**BRIGHTWATER TREATMENT PLANT
GENERAL CONTRACTOR/CONSTRUCTION MANAGER
(GCCM)**

RFP C38138C

ADDENDUM NO. 3

Figure D-1
Route 9 - 54 mgd Plant Sections
**BRIGHTWATER REGIONAL
WASTEWATER TREATMENT SYSTEM**

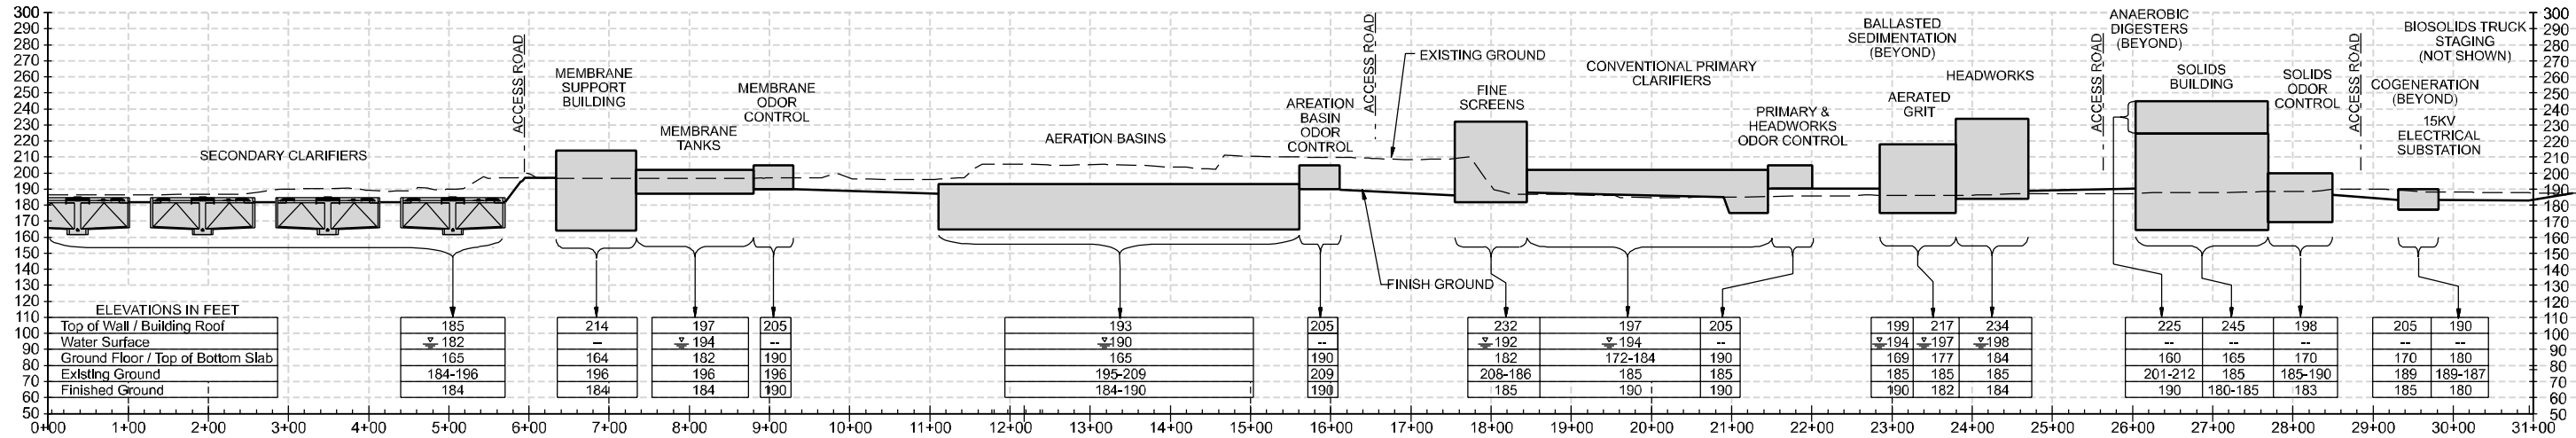
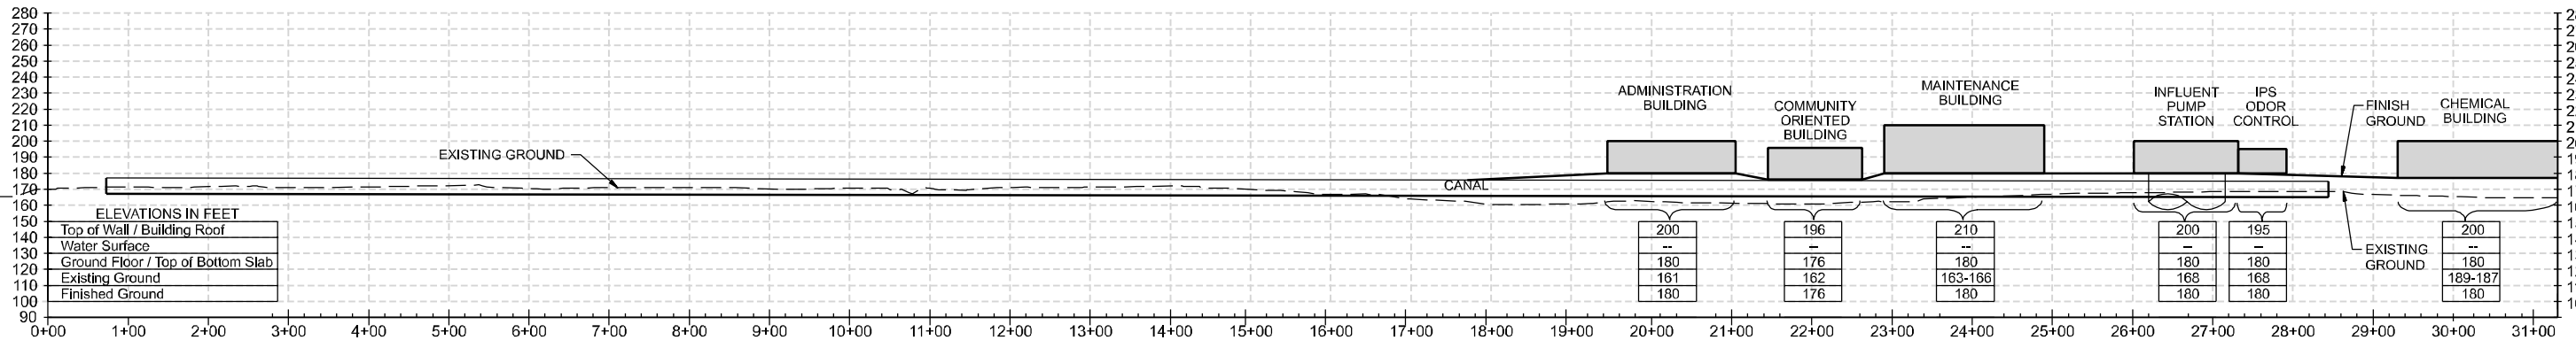
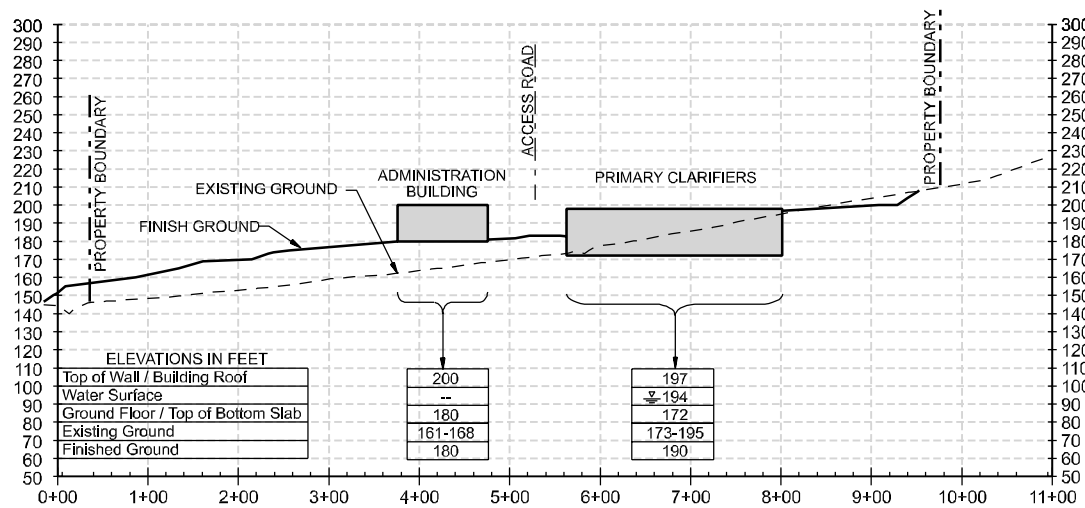
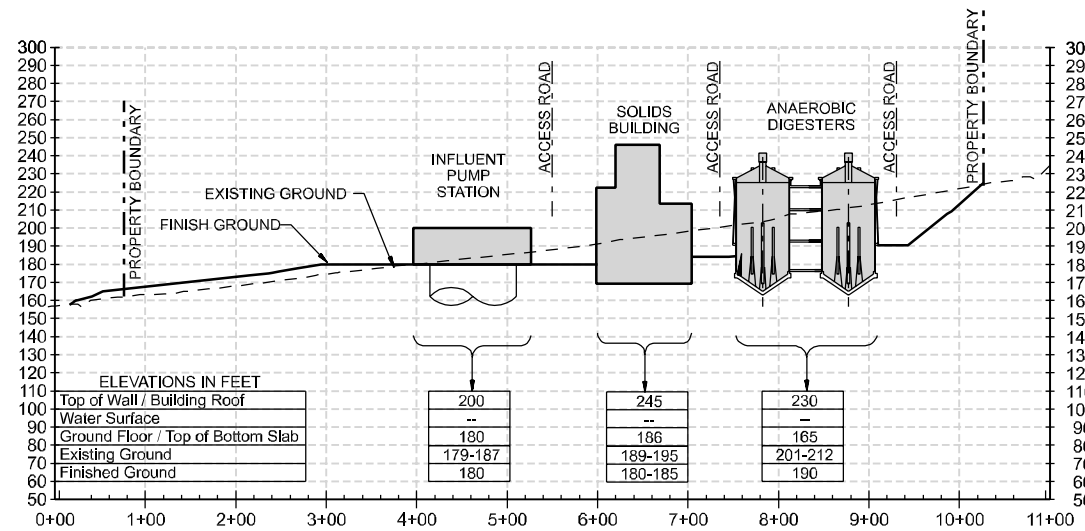
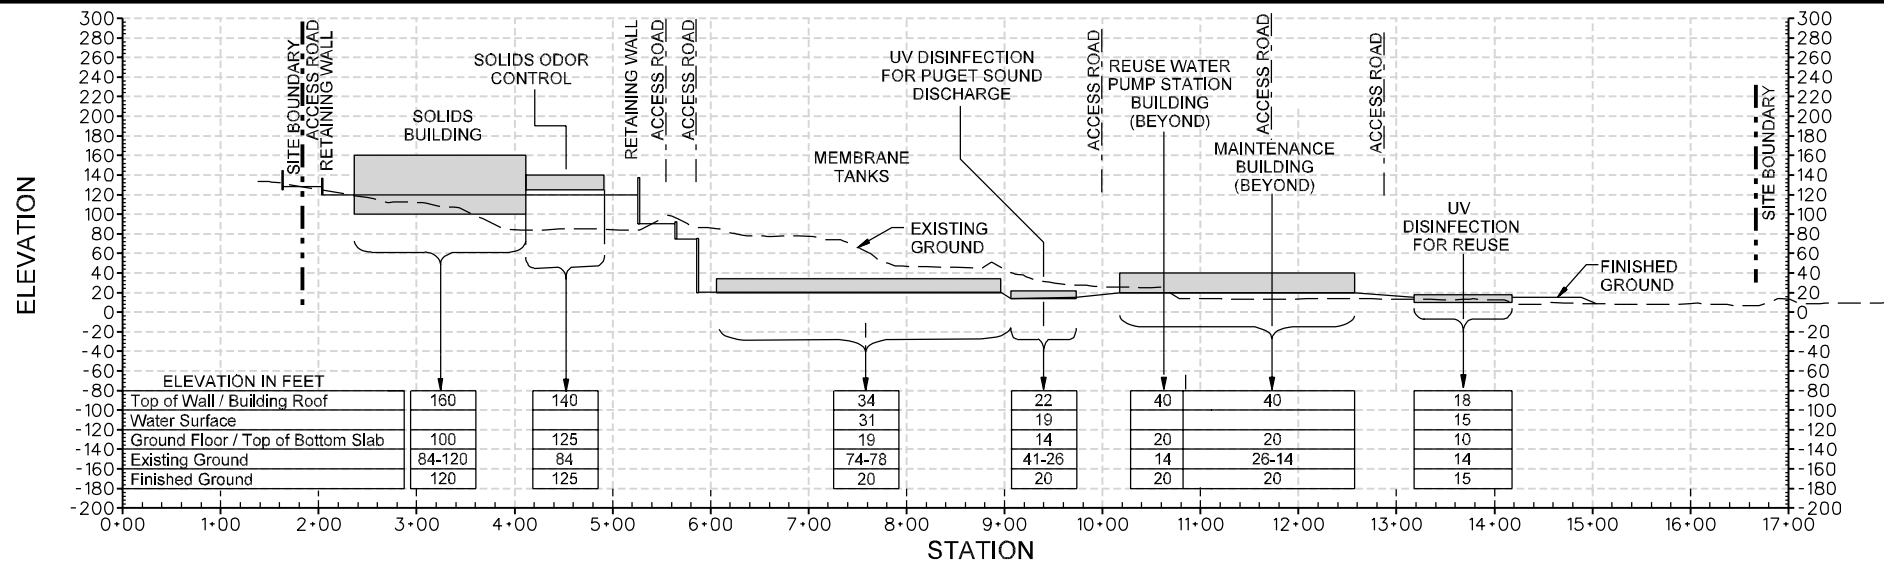
| Ref. | Page or Drawing | Location and Description of Change |
|------|-----------------|---|
| 3.8 | Question | Are preliminary hydraulic profiles available for both the Route 9 and the UNOCAL sites? |

| Ref. | Page or Drawing | Location and Description of Change |
|------|-----------------|---|
| | Response | Yes. See the attached Figures D-1 through D-3 (Plant Sections) from Attachment D - Sections, of Appendix 3A. |
